Access Compliance Report Public Rights-of-Way (Curb Ramps)

Main Street: CRESTKNOLL_DR Cross Street: GLENKNOLL_DR Location: NE

ADA ID: RPAT210923090310 Ramp Type: Type 3 - Combination 1 Initial Pass/Fail: Fail Overall Compliance: No Severity Score: 35

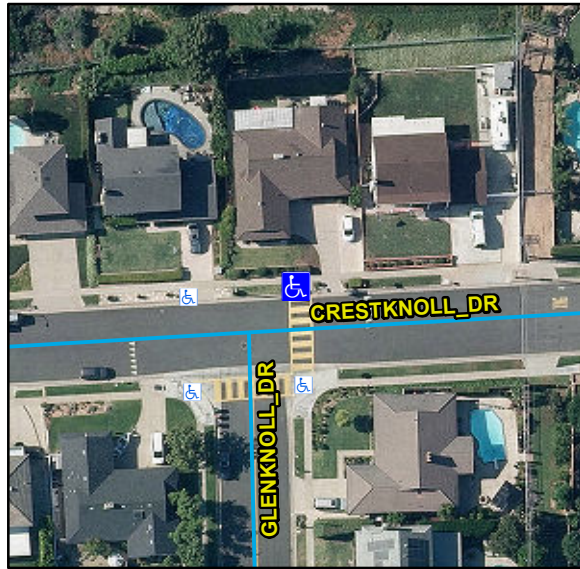
R304.2.2, R304.5.1, R304.5.3, R304.3.2, STD 1115

Compliance	Description	Data	Compliance	Description	Data
N/A	Ramp Length LT (in)	58	N/A	Ramp Length RT (in)	61
No	Ramp Width LT (in)	47	No	Ramp Width RT (in)	47
Yes	Ramp Run Slope LT (%)	3.6	No	Ramp Run Slope RT (%)	13.3
Yes	Ramp Cross Slope LT (%)	1.7	No	Ramp Cross Slope RT (%)	3
N/A	Ramp Length (in)	65	N/A	Flare Type LT	
No	Ramp Width (in)	42			N/A
No	Ramp Run Slope (%)	8.8	N/A	Flare Slope LT (%)	N/A
No	Ramp Cross Slope (%)	2.4	N/A	Flare Traversable LT	N/A
N/A	Landing Present	N/A	N/A	Flare Type RT	
N/A	Landing Length (in)	N/A			N/A
N/A	Landing Width (in)	N/A	N/A	Flare Slope RT (%)	N/A
N/A	Landing Run Slope (%)	N/A	N/A	Flare Traversable RT	N/A
N/A	Landing Cross Slope (%)	N/A	N/A	DWS Provided	N/A
N/A	Landing Movement Obstructed?	N/A	N/A	DWS Contrast	N/A
	Landing Movement Type	N/A	N/A	DWS Length (in)	N/A
N/A	Landing Shared	N/A	N/A	DWS Full Width	N/A
N/A	Clear Space	N/A		DWS Offset Type	N/A
N/A	Clear Space To Crosswalk (in)	N/A	N/A	DWS Offset Left (in)	N/A

Remove & Replace Entire Ramp.
